**MEMORANDUM**

**DATE:** MAY 21 1999

**SUBJECT:** National Remedy Review Board Recommendations for the Sheboygan River and Harbor Superfund Site

Figure 1

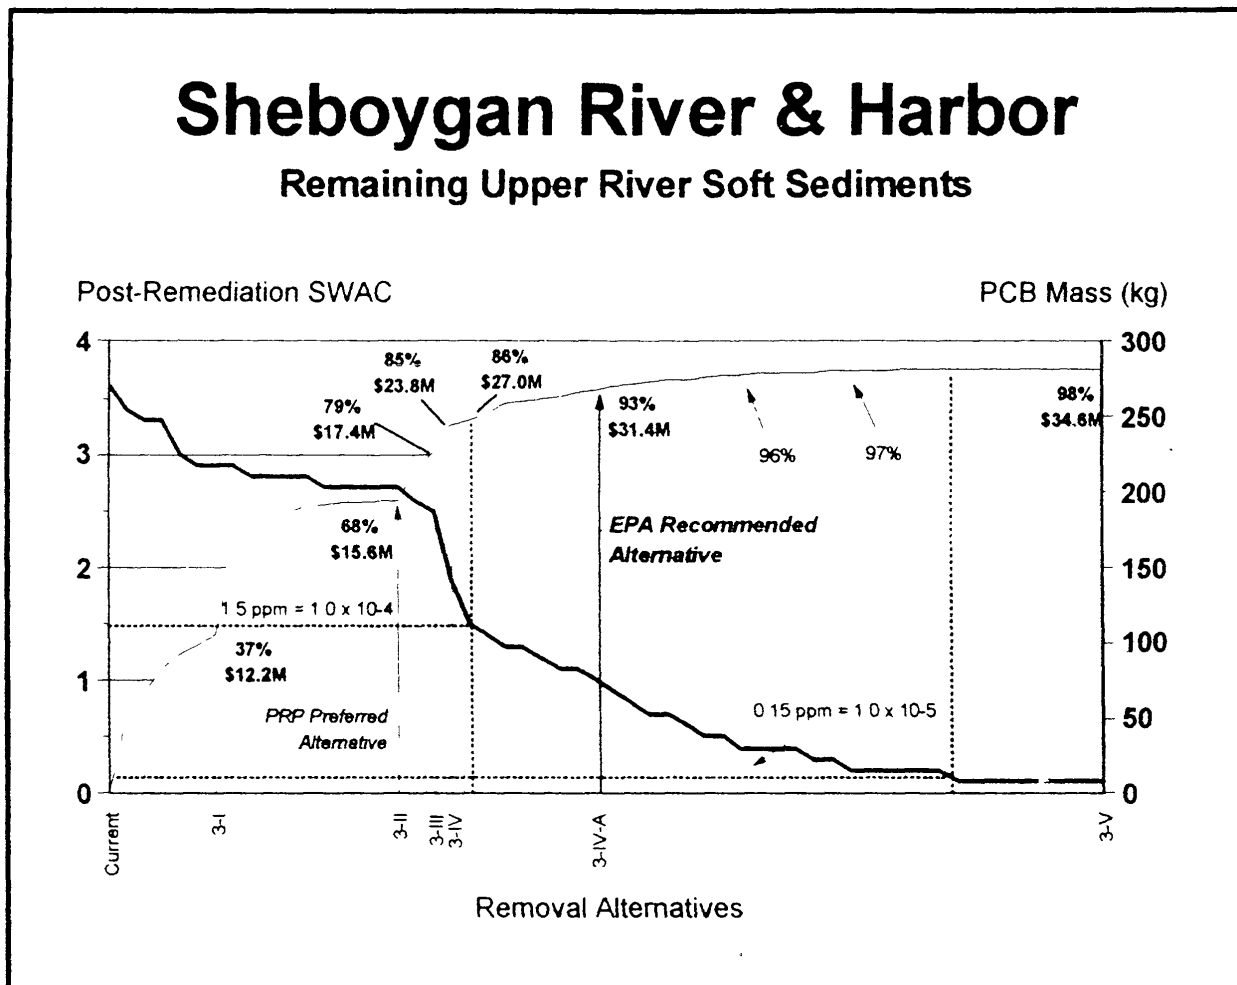
Based on the regional presentation and discussion on the range of alternatives considered for the upper river, there remain questions about how the costs, residual risks, and cleanup time frames compare among the alternatives. The region should more thoroughly evaluate how these factors change among alternatives to help identify appropriate mass removal and/or SWAC targets. The sensitivity of key assumptions important to the analysis of each factor should also be evaluated.

As seen in Figure 1, as you move through the soft sediment removal alternatives, you gradually remove more of the remaining PCB mass with increases in cost. The PRP's preferred alternative 3-II removes approximately 68% of the remaining PCB mass in the Upper River at a cost of approximately \$15,600,000. There continues to be a substantial increase in PCB mass removal between alternatives 3-II and 3-IV with alternative 3-IV removing approximately 85% of the remaining PCB mass at a cost of \$23,800,000. As you move beyond alternative 3-IV the rate of PCB mass removed gradually decreases and begins to level off between 93% and 96%. However, reductions in SWAC, and therefore risk, continue to decrease steadily until approximately 97% of the remaining mass is removed from the system.

Figure 1 also shows how the various alternatives compare to the  $1.0 \times 10^{-4}$  and  $1.0 \times 10^{-5}$  risk levels. The PRP preferred alternative 3-II, does not meet the  $1.0 \times 10^{-4}$  risk level for soft sediments.

As is described in the response to NRRB Comment #1, achievement of an overall river PCB SWAC of 1.0 ppm is highly sensitive to changes in soft sediment and non-soft sediment SWAC ratios and variances in PCB half-life timeframes. These factors are directly impacted by the amount of remaining PCB mass left in the river system. Given the uncertainty with SWAC and the PCB half-life analysis, the bio-available threat of remaining contaminated sediment, the under-represented human health risks, and the remaining adverse impacts to aquatic receptors, the soft sediment PCB SWAC target of 1.0 ppm will reasonably achieve a risk management target of  $7.0 \times 10^{-5}$ . The PRP soft sediment PCB SWAC target of 2.6 ppm, results in a risk level of  $2.0 \times 10^{-4}$  and does not satisfy the threshold criteria of protection of human health and the environment for soft sediments.
